Access Compliance Report

Public Rights-of-Way

(Curb Ramps)

Intersection ID: 15515	Main Street: BERKSHIRE_RD	Cross Street: LAWDALE_RD	Location: W
ADA ID: 737E1960BDF4	Ramp Type: PerpDiag	Initial Pass/Fail: Fail	Overall Compliance: No
Codes/Mitigation Info/Possible Solution		Field Measurements/Component Compliance

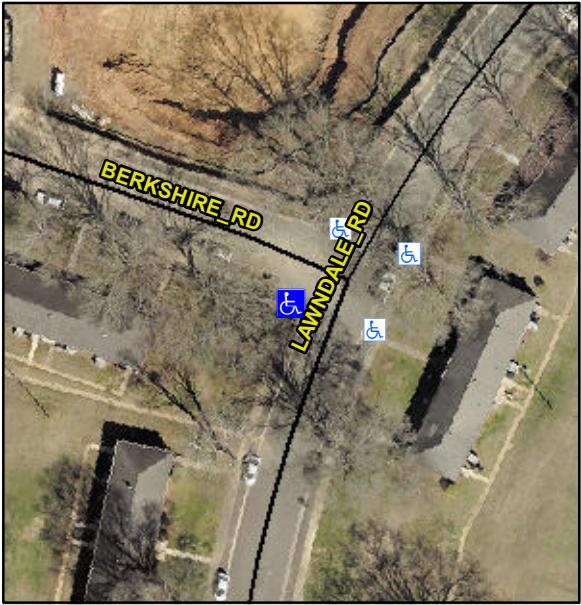
Possible Solutions:	Compliance	Description	Data	Compliance	Description	Data
	Remove & Replace Curb Ramp With Two New Directional Ramps or Equivalent.	N/A	Ramp Length (in)	62.0	No	Ramp Slope (%)	15.0
<p>Surveyor Notes:</p> <p>N/A</p> <p>PROW/ADA:</p> <p>Not Found, R304.5.1, R304.2.2, R304.5.3, R302.7</p>		No	Ramp Width (in)	46.0	No	Ramp XSlope (%)	5.4
		N/A	Flare Type LT	N/A	N/A	Flare Type RT	N/A
		N/A	Flare Slope LT (%)	N/A	N/A	Flare Slope RT (%)	N/A
		N/A	Flare Traversable LT?	N/A	N/A	Flare Traversable RT?	N/A
		N/A	Landing Length (in)	N/A	N/A	DWS Provided?	N/A
		N/A	Landing Width (in)	N/A	N/A	DWS Contrast?	N/A
		N/A	Landing Slope (%)	N/A	N/A	DWS Length (in)	N/A
		N/A	Landing X Slope (%)	N/A	N/A	DWS Full Width?	N/A
		N/A	Landing Curb? (Y/N)	N/A	N/A	DWS Offset (in)	N/A
		N/A	Shared Landing?	N/A			
		N/A	Gutter Ponding?	N/A	N/A	Gutter Slope (%)	N/A
		N/A	Gutter Lip Ht (in)	N/A	N/A	Gutter X Slope (%)	N/A

N/A	Painted X Walk1?	No	N/A	Painted X Walk2?	No
			X Walk 1 Direction	To SE		X Walk 2 Direction	To NE
		N/A	X Walk 1 Width (in)	N/A	N/A	X Walk 2 Width (in)	N/A
			X Walk 1 Slope (%)	2.8		X Walk 2 Slope (%)	0.4
			X Walk 1 X Slope (%)	0.7		X Walk 2 X Slope (%)	1.2
		N/A	Ramp inside XWalk1?	N/A	N/A	Ramp inside XWalk2?	N/A
			Road Slope (%)	0.9	N/A	Clear Space?	N/A
			Road X Slope (%)	2.4	N/A	Clear Space to XWalk (in)	N/A
		N/A	Any Obstructions?	N/A	N/A	Storm Grate/Utility Hazard?	N/A
			Obstruction Type			Storm Grate/Utility Type	
				N/A			N/A
				No		Surface Condition? (G/P)	Poor
Total Cost:		\$	3200.00
